**GS# 104-215 Jones Hall Interior Renovations  
Mississippi University for Women**

Addendum No. 2

SHEET **F101**

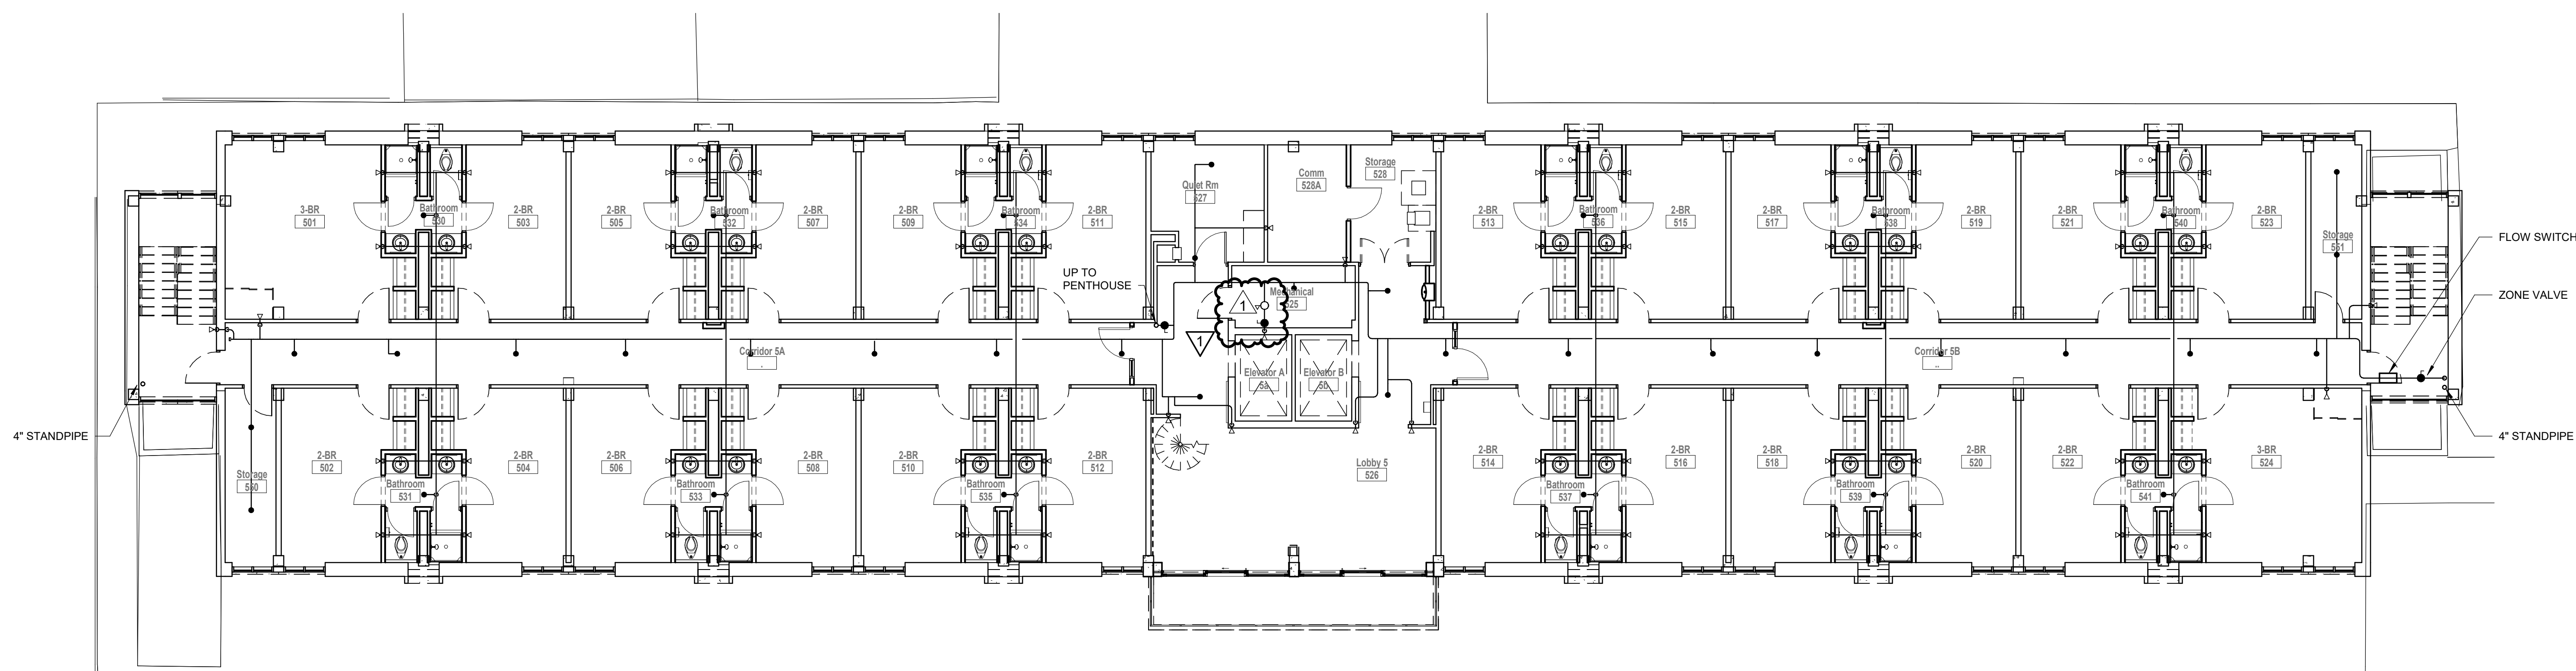
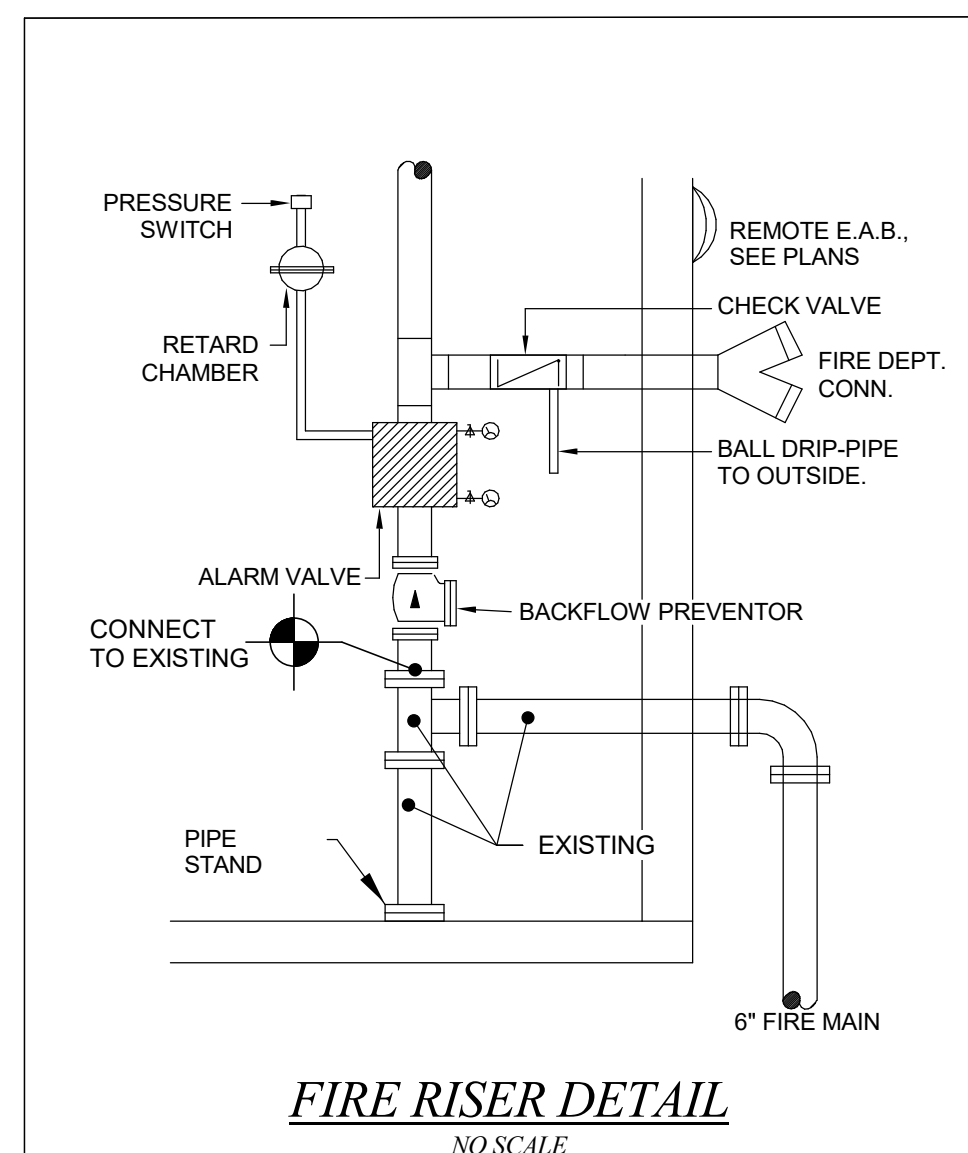
- a. 2/A101: rebar spacing shall be 12” O.C. maximum
- b. 8/A401: Wall tile shown in Kitchen Int Elevation shall be WT-1
- c. Revise Sheet F101 and replace with attached Sheet F101. Revisions included adding a flow switch and isolation valve to sprinkler line serving the elevator shaft.

- PROVIDE NEW FIRE RISER ASSEMBLY IN EXISTING LOCATION. ROUTE NEW PIPING THROUGH EXISTING SERVICE HOLES IN PLEXIGLASS TO CONNECT TO EXISTING 6" MAIN 12" A.F.F. SEE DETAIL FOR MORE INFORMATION.
- PROVIDE FLOW SWITCH AND ISOLATION VALVE IN LINE WITH SPRINKLER LINE SERVING ELEVATOR PIT.

SHEET **F105**

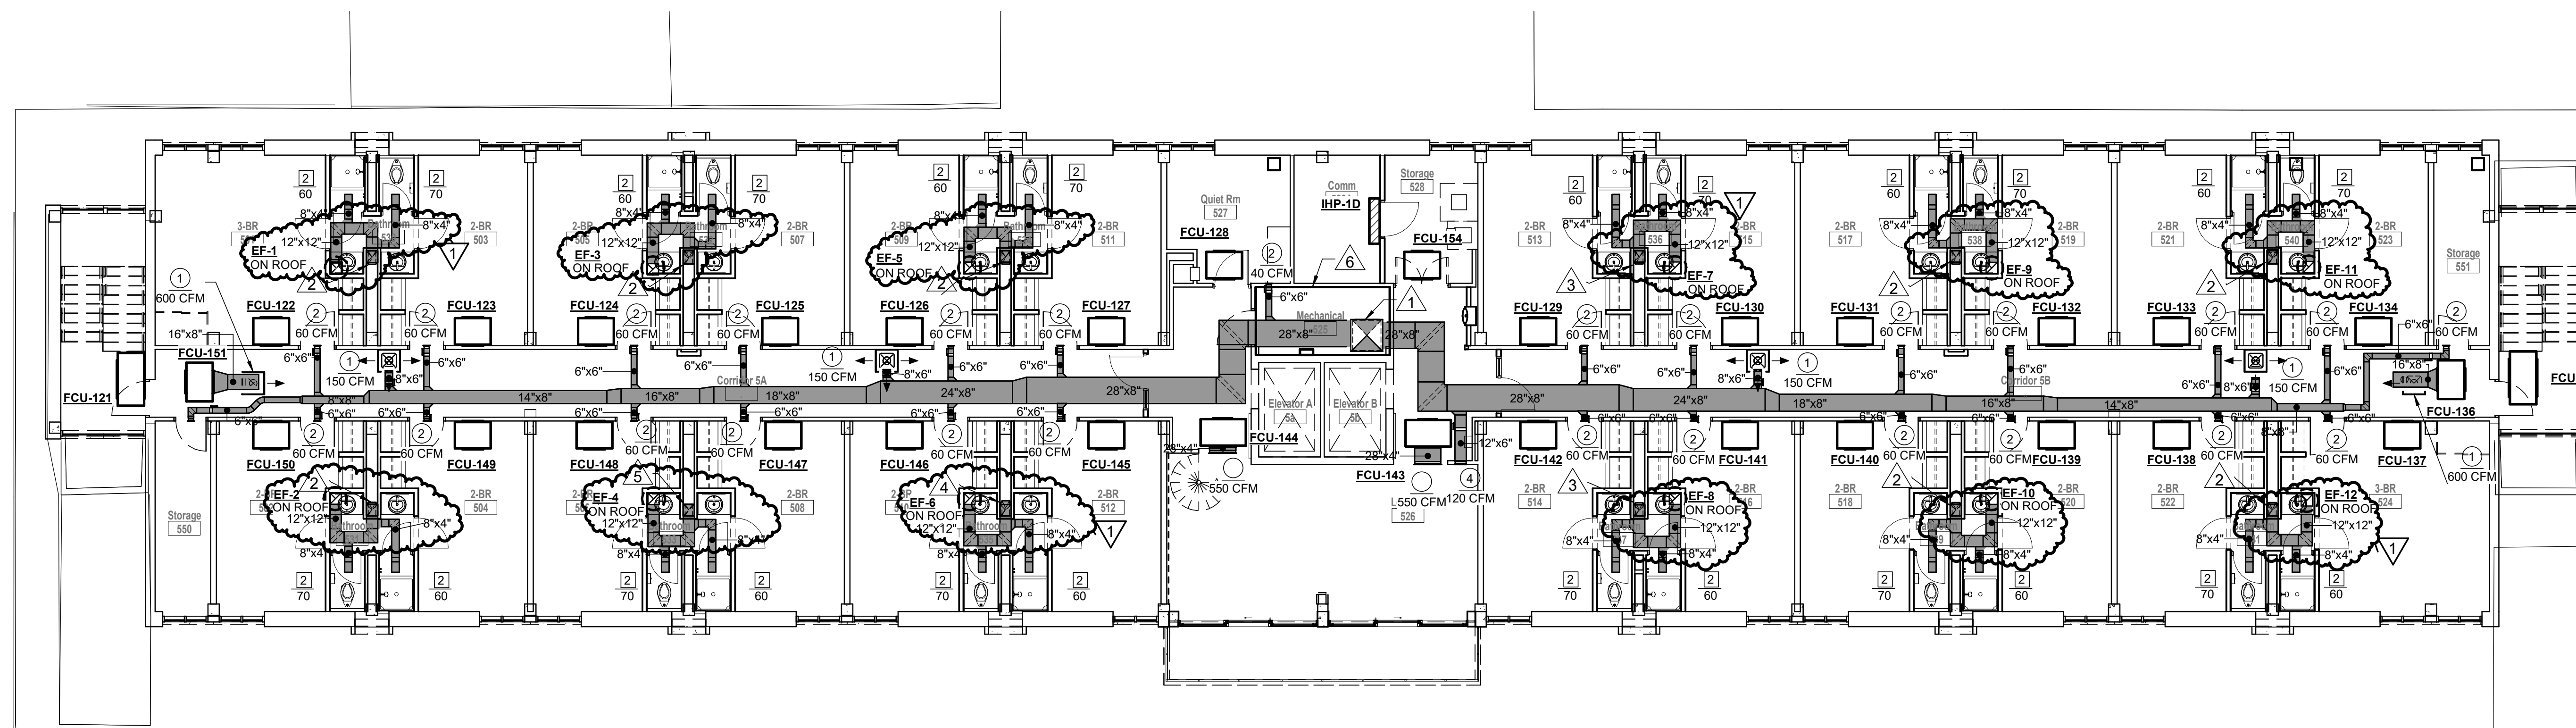
- d. Revise Sheet F105 and replace with attached Sheet F105. Revisions included adding a flow switch and isolation valve to sprinkler line serving the elevator shaft.

**NOTES:**  
 PROVIDE FLOW SWITCH AND ISOLATION VALVE IN LINE WITH SPRINKLER LINE SERVING ELEVATOR PIT.

SHEET **M105**

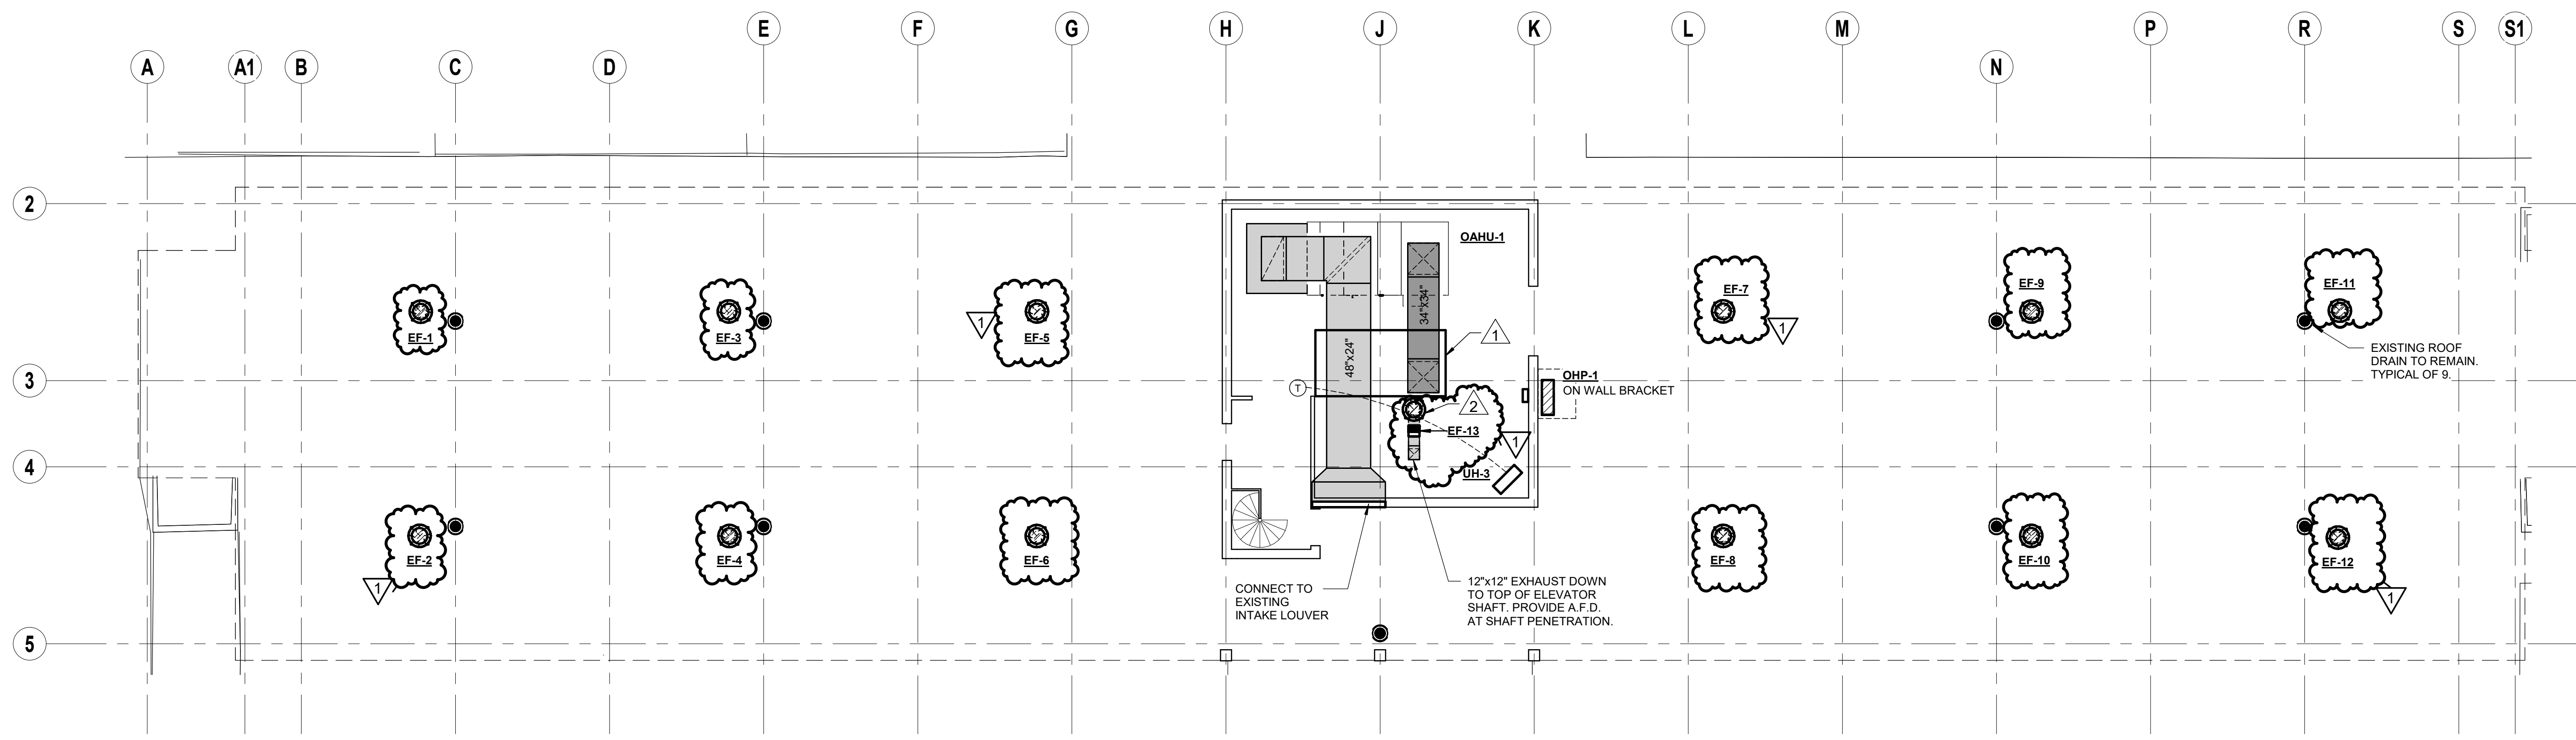
- g. Revise Sheet M101 through M105. Provide a general note to state the following, “Provide painted 1”x2”x1/8” aluminum angle under dorm room fan coil units. Angle to be full length of

fan coil and attached at the bottom of the unit against the wall (see detail on sheet P301). Angle provided is intended to cover openings in existing block wall where supply grilles were removed.”

- h. Revise Sheet M105 and replace with attached Sheet M105. Revisions included updating the location of the ductwork to match the new locations of the roof mounted exhaust fans, and adding a general note.
